REMARKS

In the office action mailed April 26, 2005 (the "Office Action"), the Examiner objected to the drawings and further objected to claims 1, 4, 9, and 13-16, based on informalities. The Examiner also rejected claims 1-22 under 35 U.S.C. 112, second paragraph.

Fig. 5

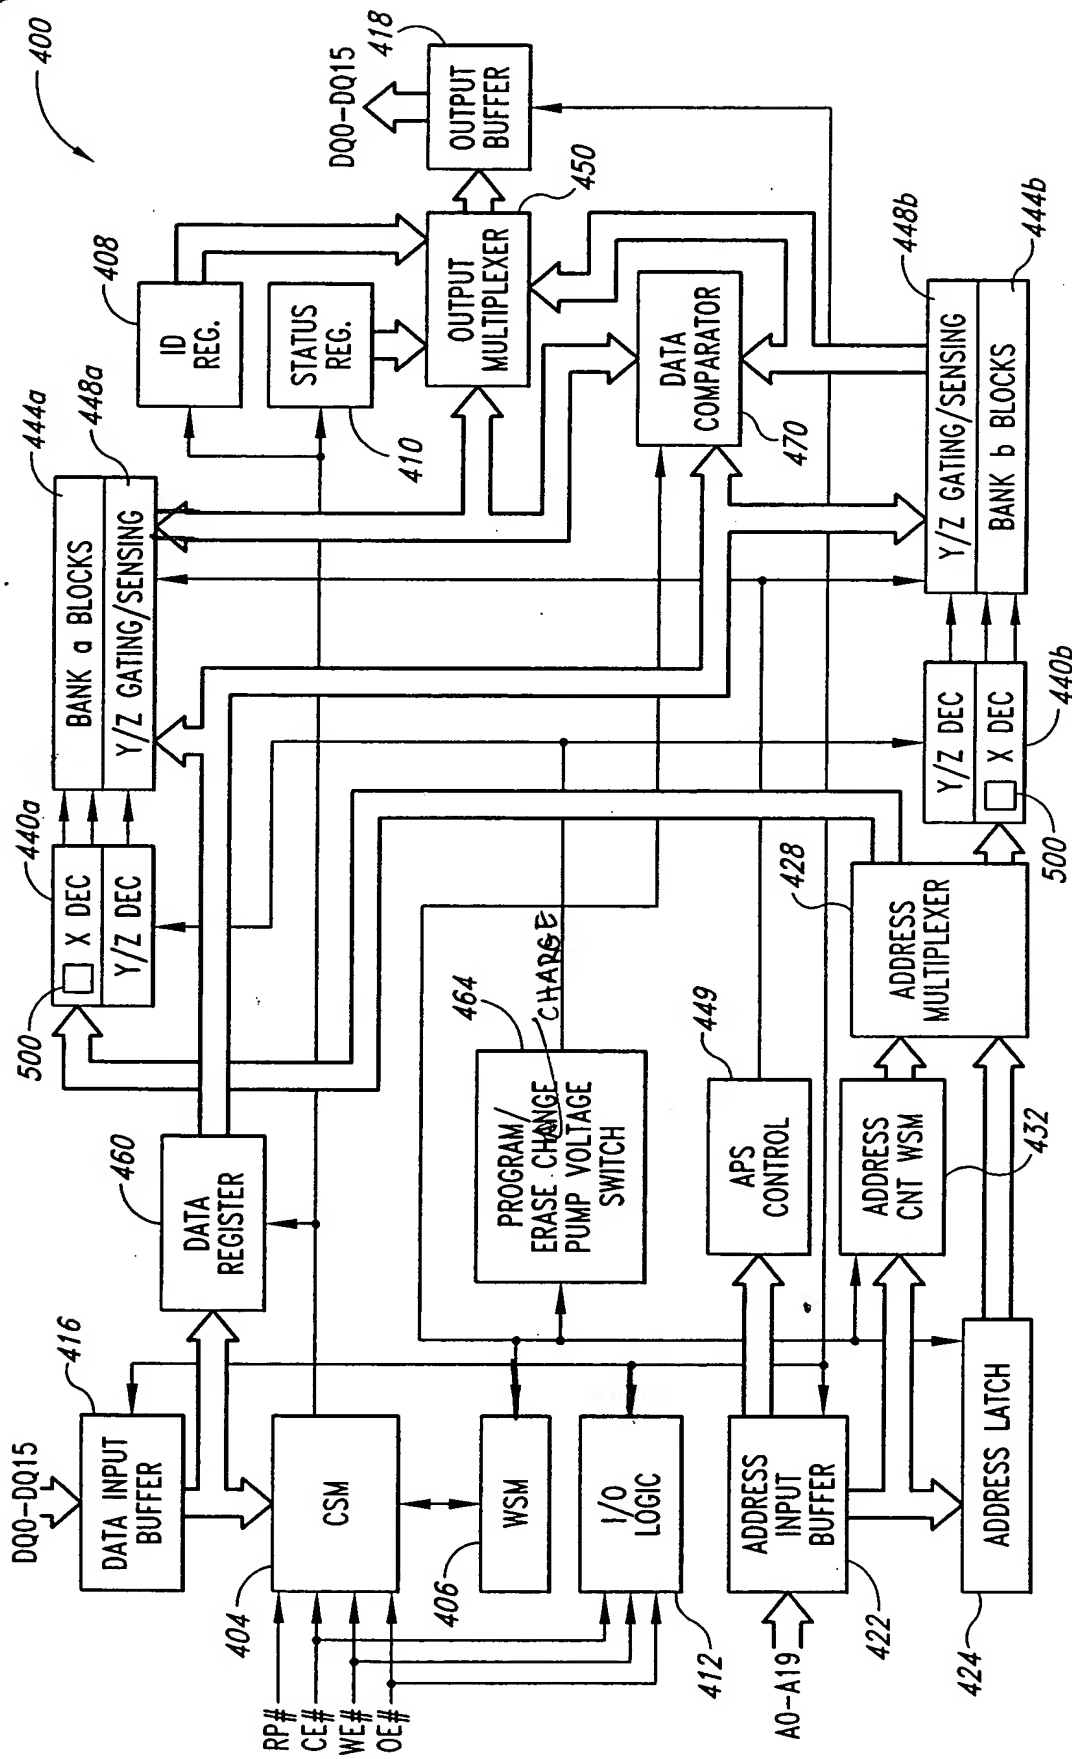
With respect to the Examiner's objections to the drawings, Figures 3 and 5 have been amended as suggested by the Examiner. Additionally, the specification has been amended to remove reference to the "discharge controller 300." As for the Examiner's objection to the drawings for failing to show "an input signal" and "a test signal," Figure 4 illustrates an input signal and a test signal. In the embodiment illustrated in Figure 4, the input signal is generated at the node 514 by the PMOS and NMOS transistors 510, 512. The input signal at the node 514 has a HIGH logic level in response to the VXDECEN# and XPDA signals having LOW logic levels. Conversely, when the VCDECEN# and XPDA signals have HIGH logic levels, the input signal at the node 514 has a LOW logic level. Operation of the row driver 500 in response to the input signal at the node 514 and the VXDECEN# and XPDA signals is described at page 7, line 23-page 8, line 17. In the embodiment of the row driver shown in Figure 4, the test signal corresponds to the PSM signal that is provided to the isolation circuit 502. As described in the present application, the PSM signal indicates whether a flash memory is operating in a normal mode or in a power-savings mode. See page 7, lines 20-21. Operation of row driver 500 with respect to the PSM signal is described at page 7, line 23-page 8, line 17. Thus, both "an input signal" and "a test signal" are shown in Figure 4. For the foregoing reasons, the Examiner's objections to the drawings should now be withdrawn.

Figure 5 has been amended to correct a typographical error in circuit block 464, to remove an arrow pointing to WSM 406, to remove an arrow pointing to the I/O Logic 412, and to remove "the third arrow pointing to the right bottom side of circuit block 448a".
